**DEPARTMENT OF TRANSPORTATION
STATE OF GEORGIA**

FILE P.I. # 662510-
STP00-00MS-00(007)
Gordon County
GDOT District 6 - Cartersville
South Calhoun Bypass from SR 53 @ CR 13 East
to SR53 @ CR 64

SUBJECT APPROVED REVISED CONCEPT REPORT

**DEPARTMENT OF TRANSPORTATION
STATE OF GEORGIA
REVISED PROJECT CONCEPT REPORT**

DRAWING No.
5-001

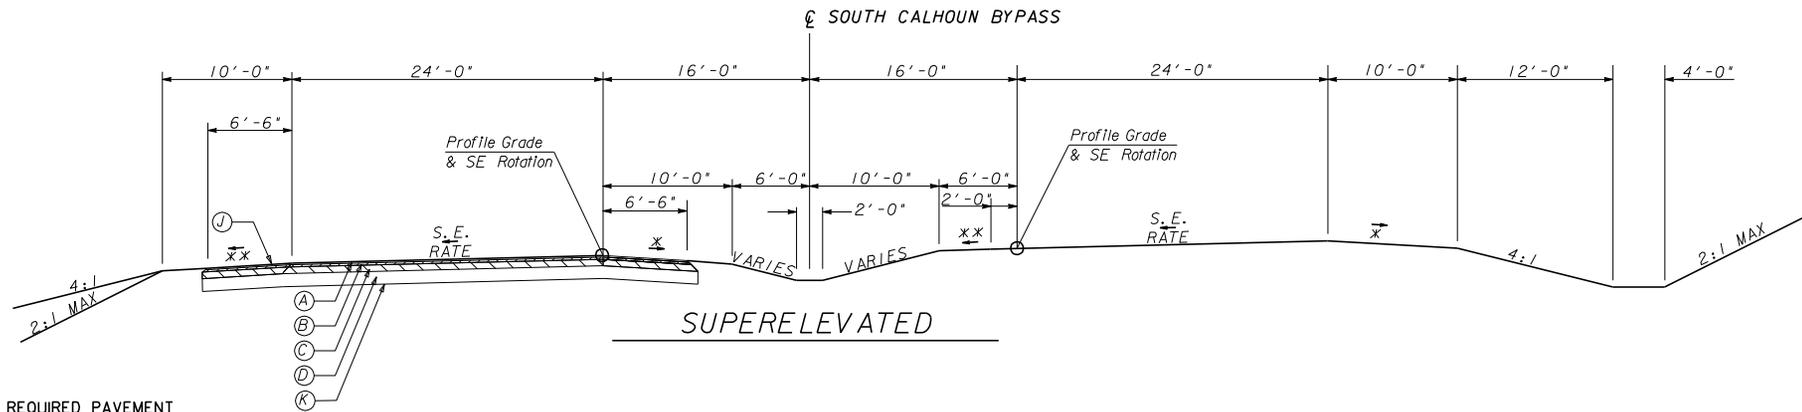
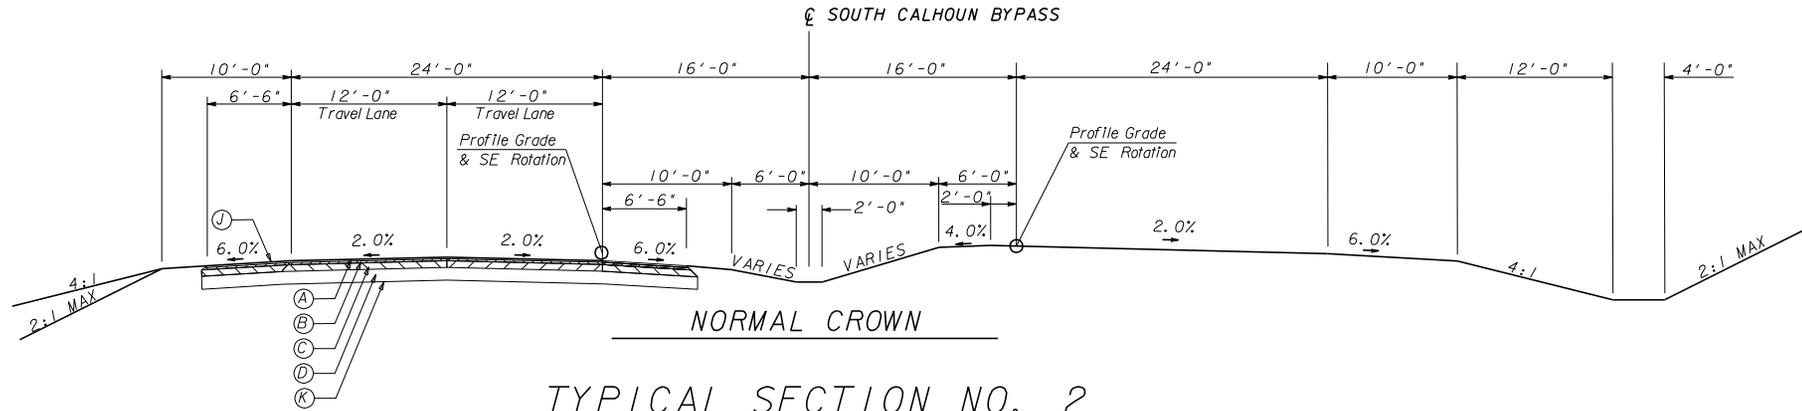
The typical section for the South Calhoun Bypass has been changed to have a 32 ft depressed grassed median and to pave only the westbound lanes to be used for two way traffic from SR 53(Western Terminus) to US 41/SR 3 per recommendation of the Value Engineering Study.

By recommendation of the Value Engineering Study to reduce costs due to decreased traffic volumes for this segment of the Bypass, only the westbound lanes will be paved. The grading for the eastbound lanes will be constructed as originally designed. The paved westbound lanes will now carry both east and westbound traffic.

GDOT Design Policy Manual now allows median widths for arterials with design speeds greater than or equal to 55 mph to be 32 ft depressed. By recommendation of the Value Engineering Study, the typical section will be revised to include a 32 ft depressed grassed median. This recommendation reduces cost and environmental impacts.
